Re: **SCI-823-6.81, Portsmouth Bypass Project, PID 19415**  
**Addendum to Report: Shumway Hollow Road (TR 234) Interchange**  
Embankment Stability, Time-Rate of Consolidation, Soil Cut Slope Stability  
DLZ Job No.: 0121-3070.03, Document No. 107

DLZ has reviewed ODOT-Office of Geotechnical Engineering's (OGE's) Stage I review comments (dated January 31, 2007) for Phase 1 of the SCI-823 project. In compliance with the review comments, DLZ has modified the slope stability analyses and time-rate of consolidation calculations for the Shumway Hollow Road (TR 234) interchange embankments. This document also elaborates on our previous recommendations for soil cut slopes and includes the output of the associated stability analyses.

Mainline Embankment-Undrained Analysis-Full Height  
SCI-823, Shumway Interchange, Stability Analysis  
Analysis Method: bishop simplified

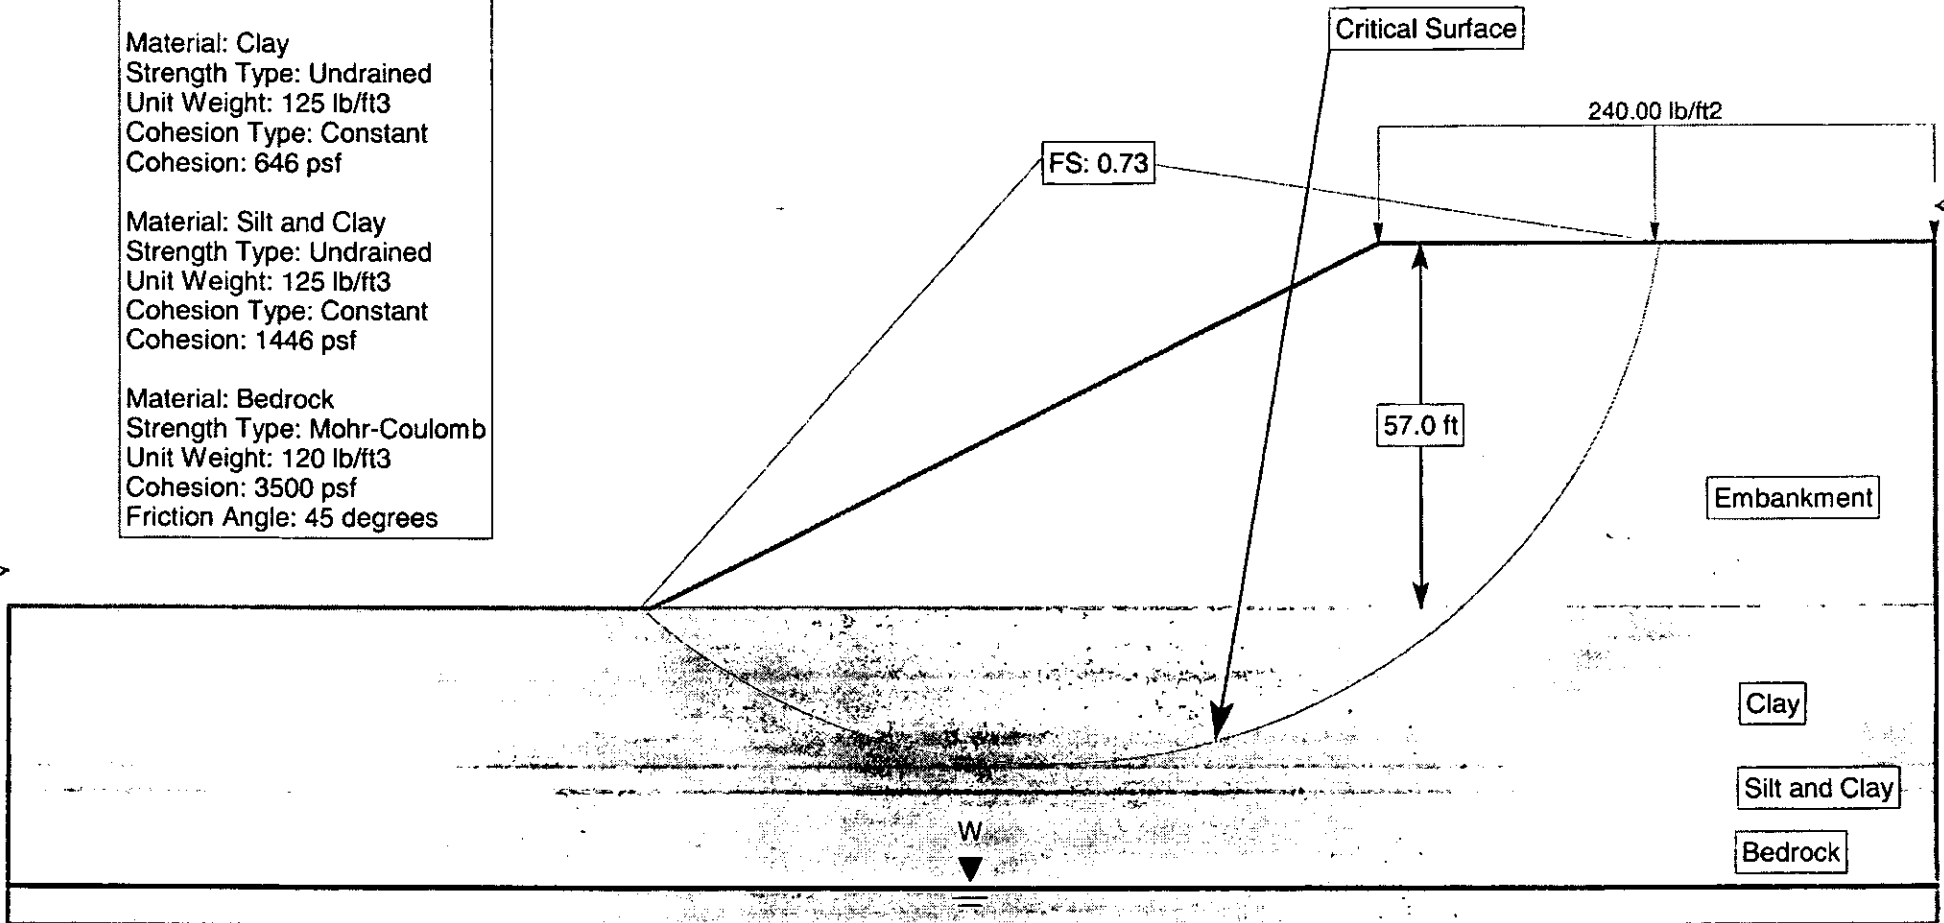
- OGE commented on the minimum required factor of safety against global stability used in the report (FS=1.25). The correct minimum required factor of safety should be 1.30 for the interchange embankments and soil cuts.

Analyses performed for the full height embankment (57 ft) yielded a critical factor of safety of 0.73 for the undrained condition, which is well below the required minimum value of 1.30. Analyses performed for the drained and seismic conditions resulted in infinite slope type failures, with factors of safety of 1.41 and 1.31, respectively. Deeper, specified surfaces also resulted in factors of safety above the minimum required factor of safety of 1.30.

- The global stability of critical embankment sections have been reevaluated using  $\Phi=35$  degrees and a standard degree of consolidation of ninety percent to estimated the consolidation times. Additionally, all global stability conditions (undrained, drained, etc.) were held to the minimum required factor of safety of 1.30. These modifications affected the embankment height during staged construction

Mainline Embankment-Drained Analysis-Full Height  
SCI-823, Shumway Interchange, Stability Analysis  
Analysis Method: bishop simplified

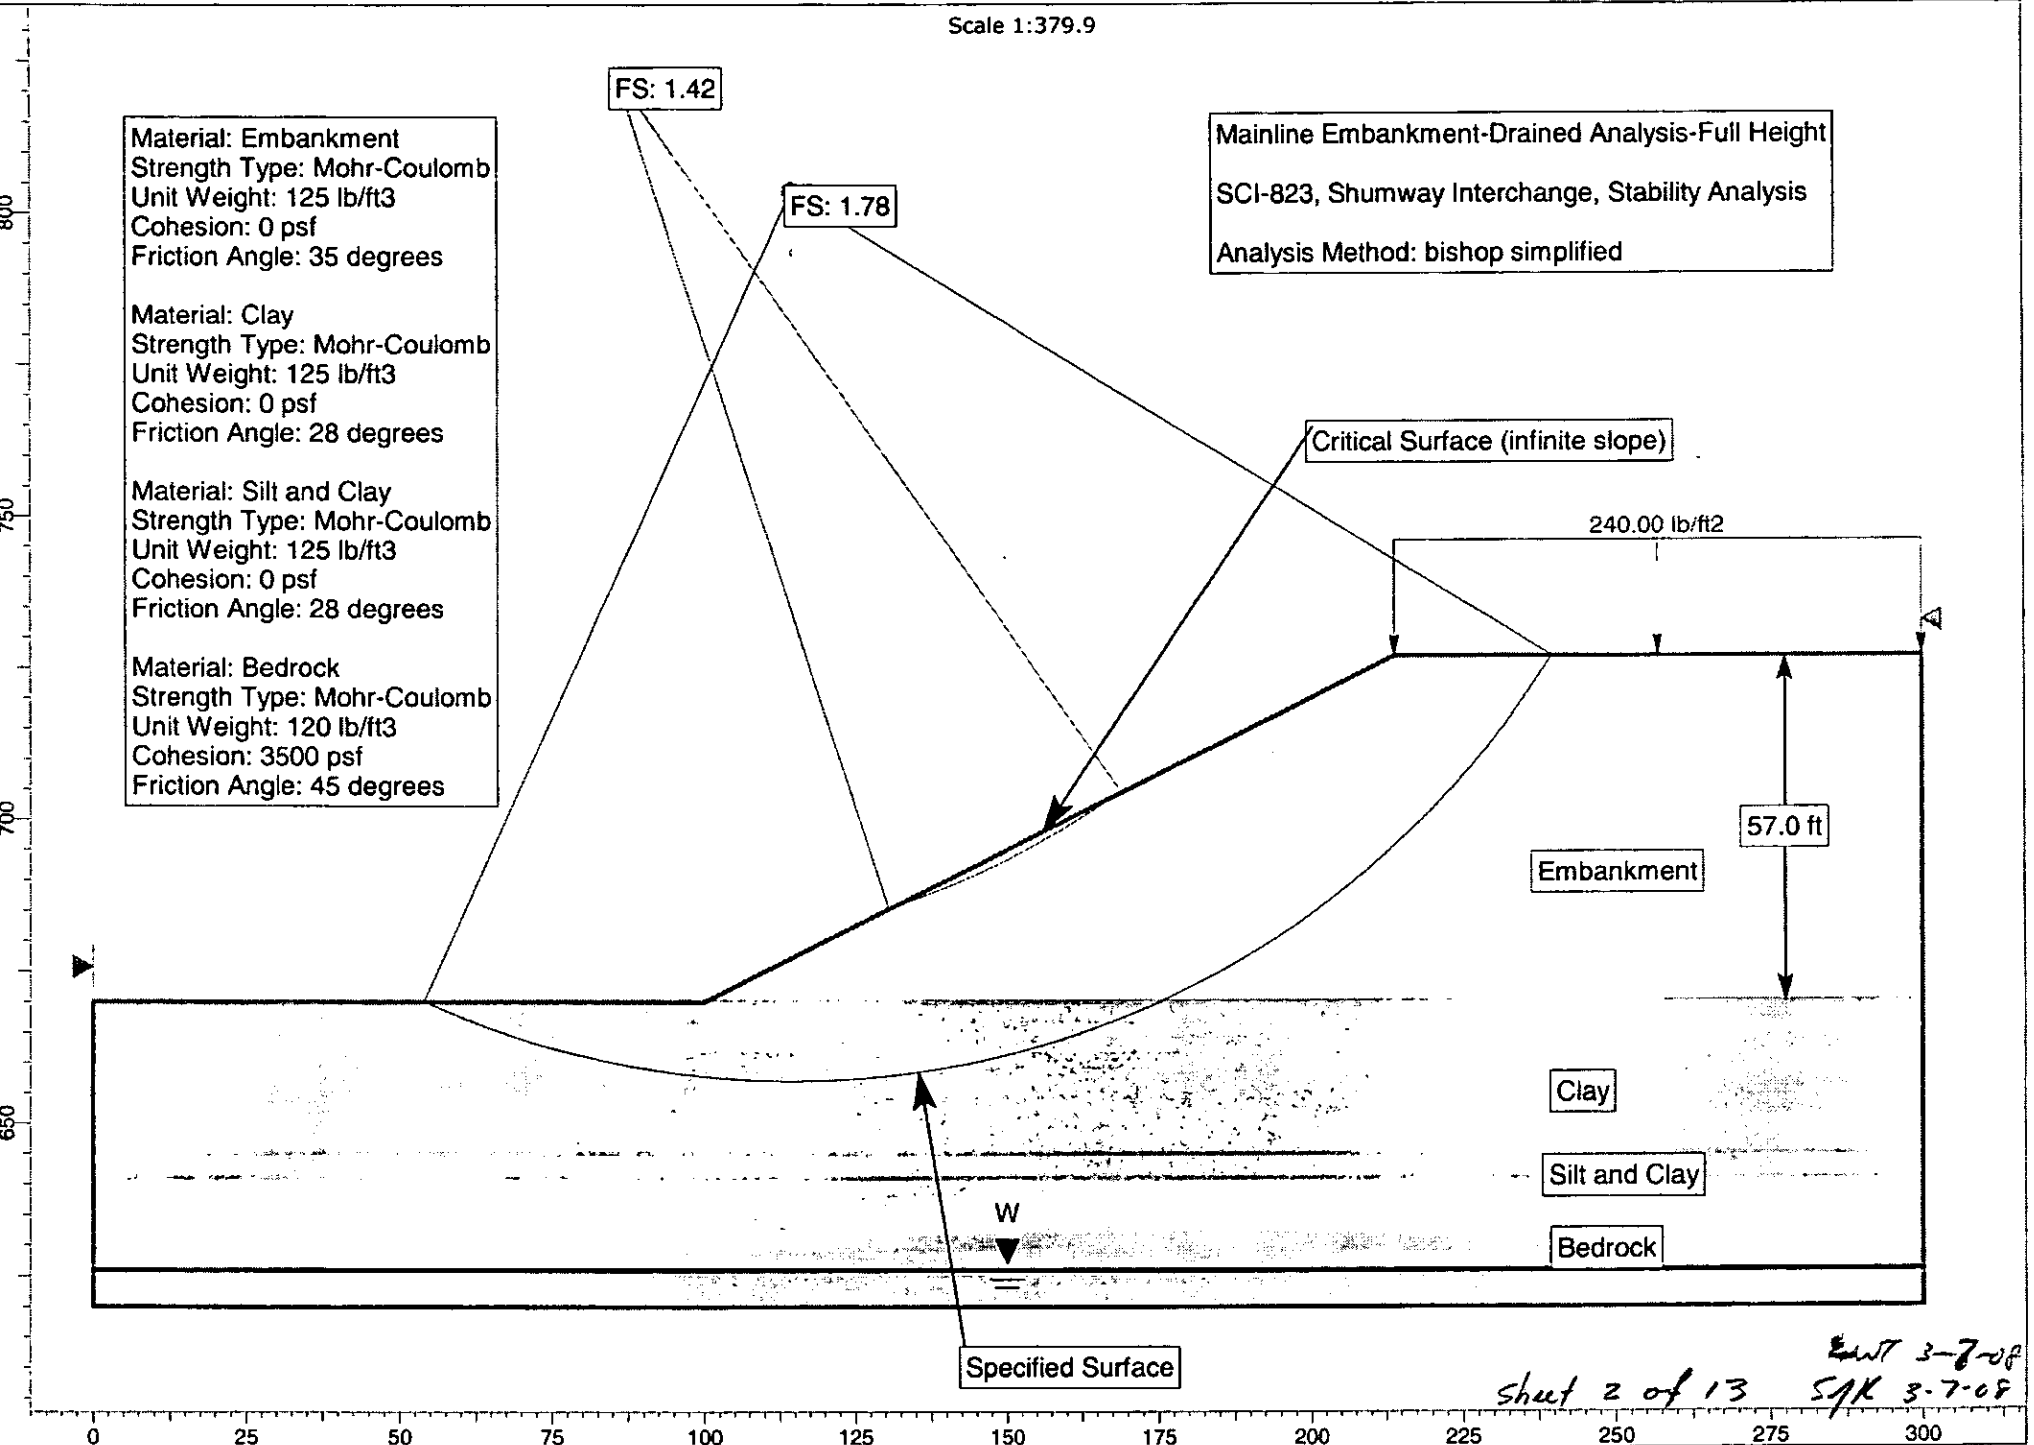
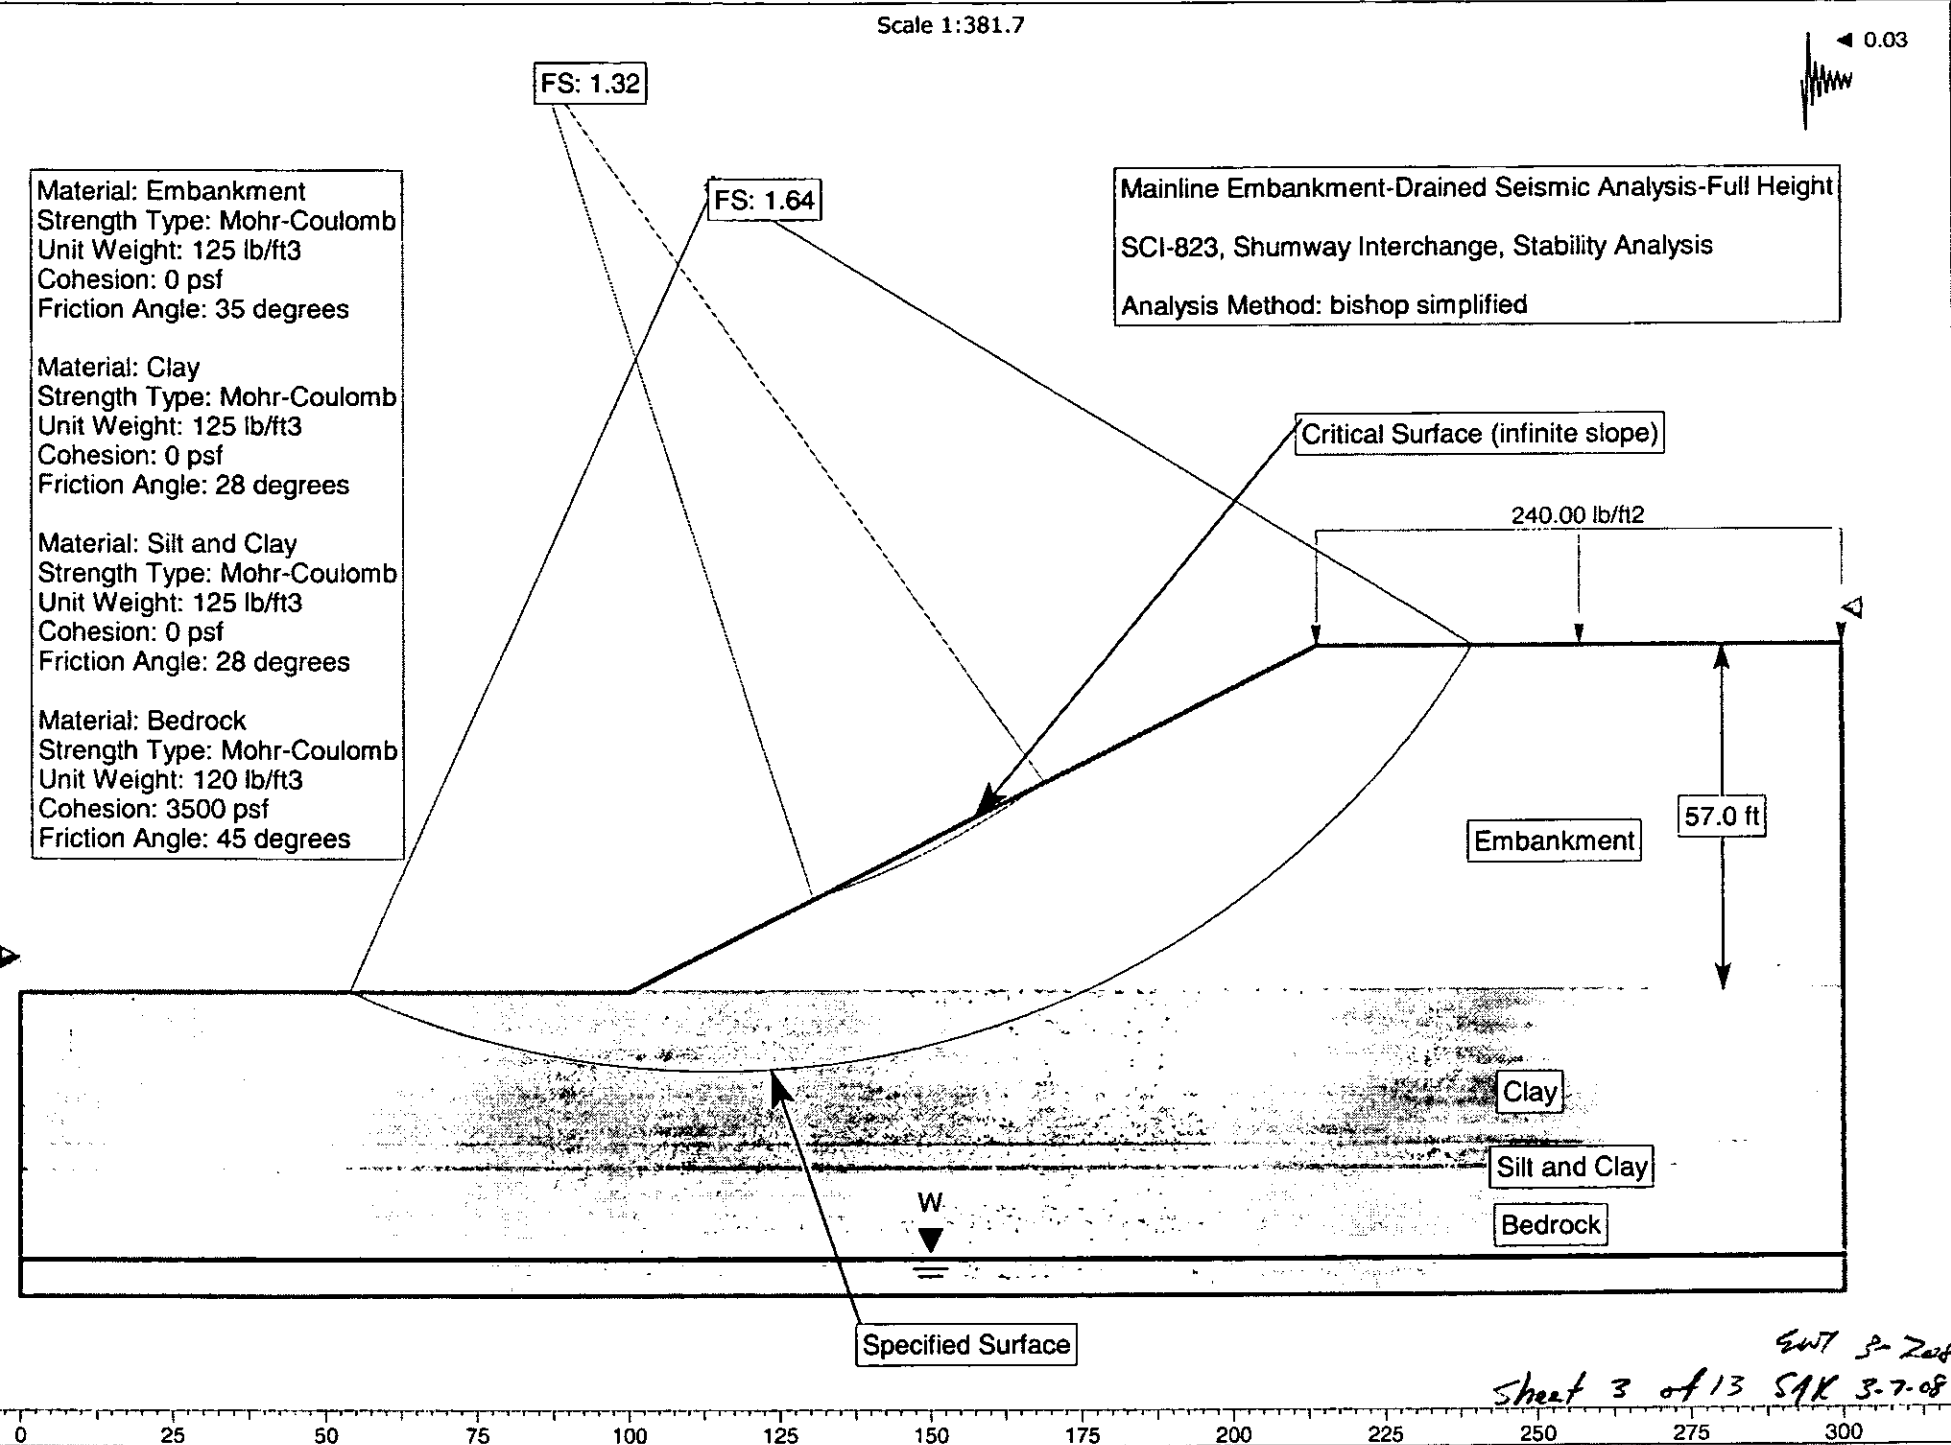
- OGE stated that DLZ should be consistent with the assumed shear strength values for the embankment fill material since some analyses used  $\Phi=32$  degrees while others used  $\Phi=35$  degrees, with no cohesion.

As per ODOT's review comments, the stability analyses have been revised to reflect consistent shear strength parameters used for the embankment fill throughout the project. The majority of the analyses contained in the interchange report used  $\Phi=35$  degrees for the embankment fill material, with some analyses using  $\Phi=32$  degrees. For consistency, the revised analyses assumed  $\Phi=35$  degrees for all of the stability analyses. In addition, the required minimum factor of safety of 1.30 was used for the global stability analyses. When citing "benchmark" consolidation periods, the standard of ninety percent consolidation ( $U=90\%$ ) was used instead of eighty percent, as cited in the report.
